AMENDMENTS TO THE DRAWINGS

Application No. 10/734,496

Atty. Docket No. 53807-00064USPT

ANNOTATED SHEET SHOWING CHANGES TO FIGURE 7

FIG. 7
(PRIOR ART)

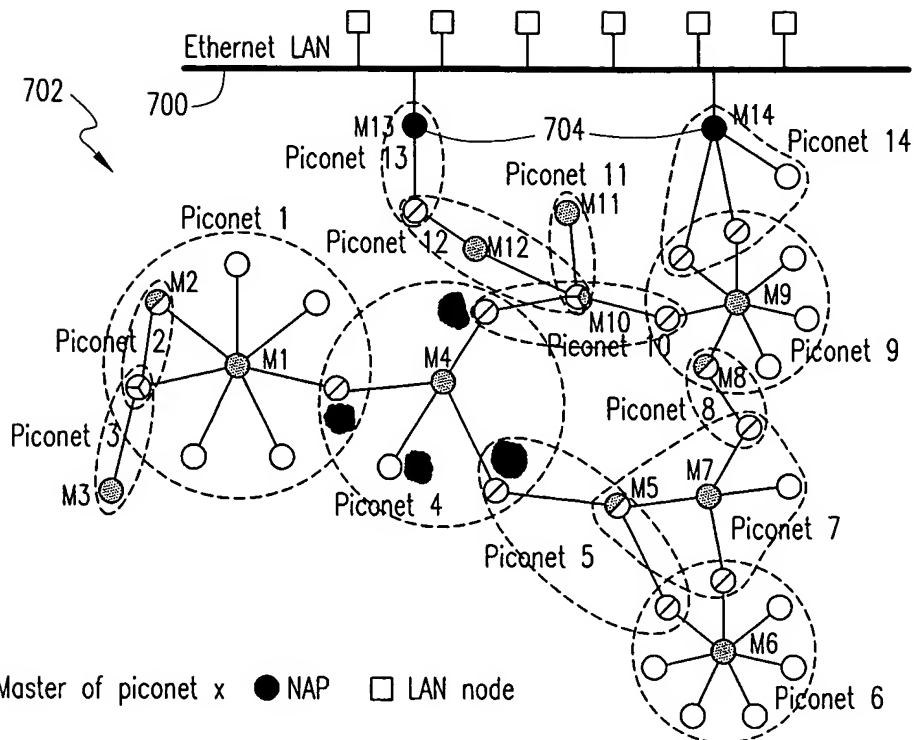
Figure 7 of the drawings is hereby amended to add the reference labels "S1," "S2," "S3," and "S4" to the four nodes directly connected to node "M4." Support for the amendment may be found in the specification in the paragraph bridging pages 31 and 32.
